# MDT Electronics

## Rev "E" Mezzanine Lite

Layout changes due to Faraday cage / patch panel interferences:

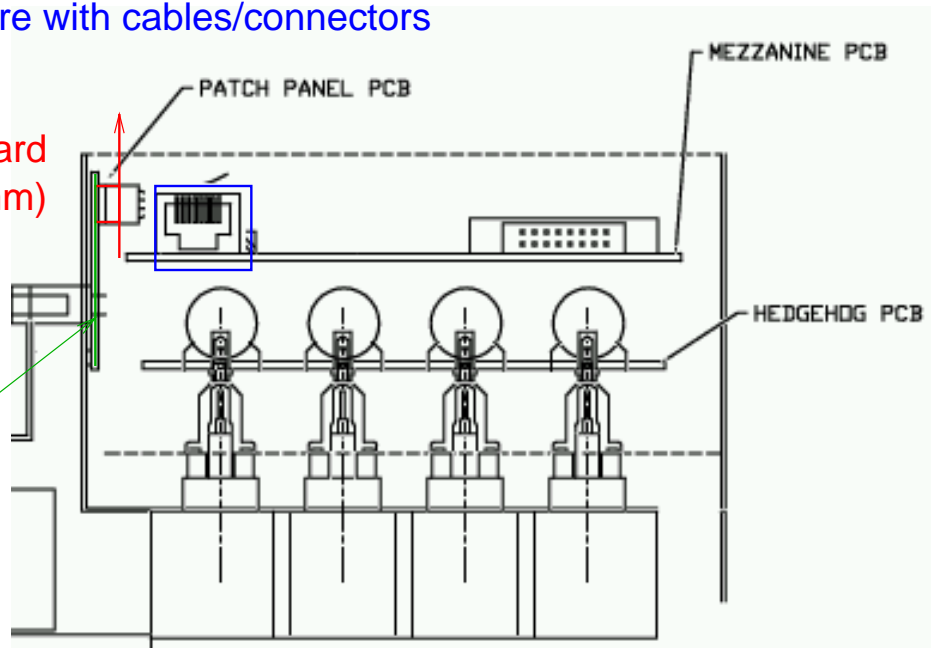
RJ-45 connectors and other components interfere with cables/connectors

Interference between board and connectors (~2mm)

Patch Panel

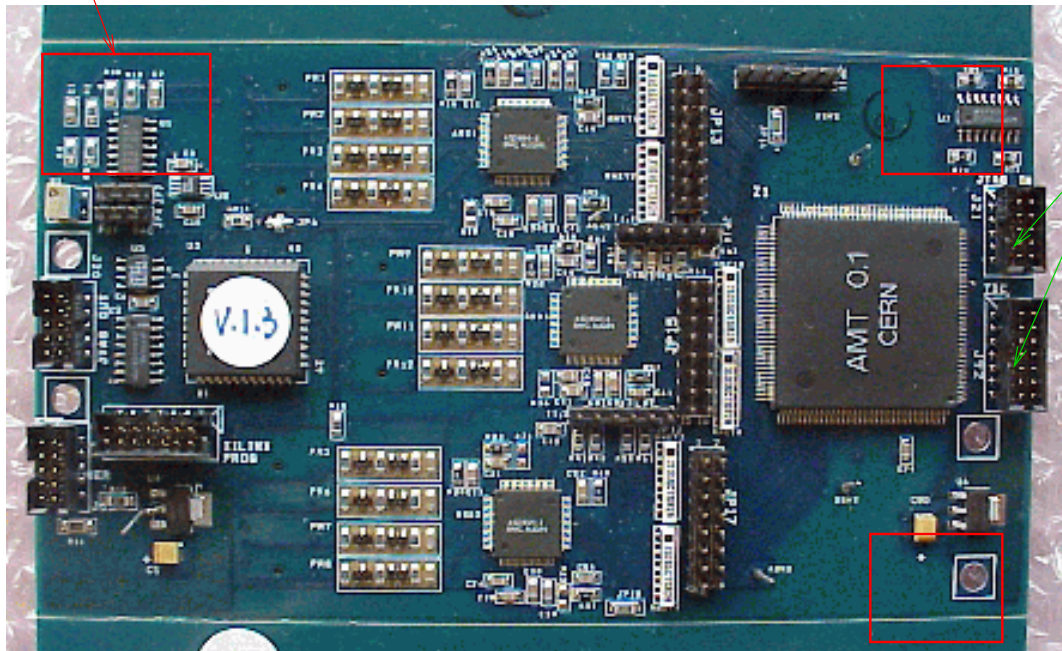
RJ-45 connectors removed

New 2mm header Connectors added

JTAG in

TDC Data

Digital power

JTAG out

Analog power
